# UNITED STATES PATENT AND TRADEMARK OFFICE

APPLICATION NO.	FILING DATE	FIRST NAMED INVENTOR	ATTORNEY DOCKET NO.	CONFIRMATION NO.
10/592,969	06/25/2008	Silvia Gerstner	2004P00358WOUS	4067

<b>Office Action Summary</b>	<b>Application No.</b> 10/592,969	<b>Applicant(s)</b> GERSTNER ET AL.	
	<b>Examiner</b> DAN ROHRHOFF	<b>Art Unit</b> 3637

## **DETAILED ACTION**

Leimkuehler Fig. 4

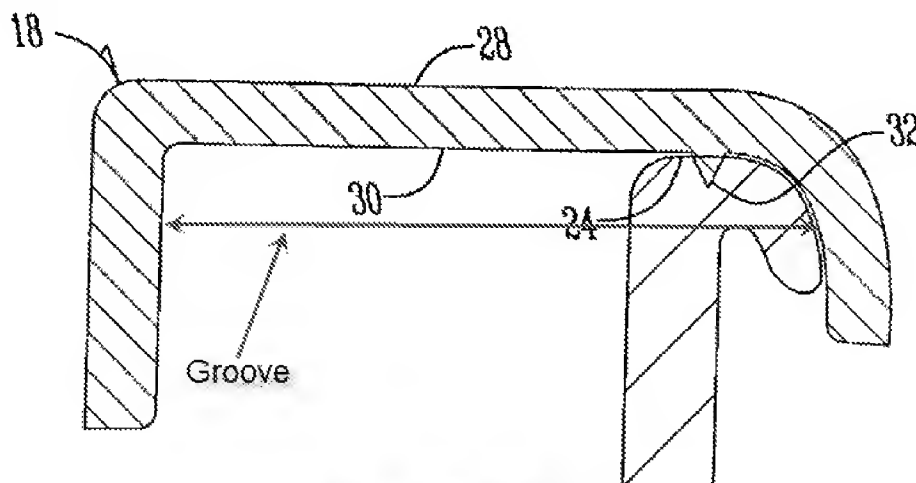
8. Regarding claim 11, Leimkuehler, as modified, teaches a refrigerator wherein the strip has a groove (see annotated Fig. 4) into which the edge of the compartment for accommodating articles to be cooled is inserted (Fig. 4).

9. Regarding claim 12, Leimkuehler, as modified, teaches a refrigerator wherein the depth direction of the groove is aligned transversely to the radius of curvature of the decorative strip (Fig. 4).

10. Regarding claim 13, Leimkuehler, as modified, teaches a refrigerator wherein the width of the groove increases, at least at certain points, from an inlet region of the groove to its bottom (Fig. 4 shows the width of the groove to increase from the top (inlet region) to its bottom).
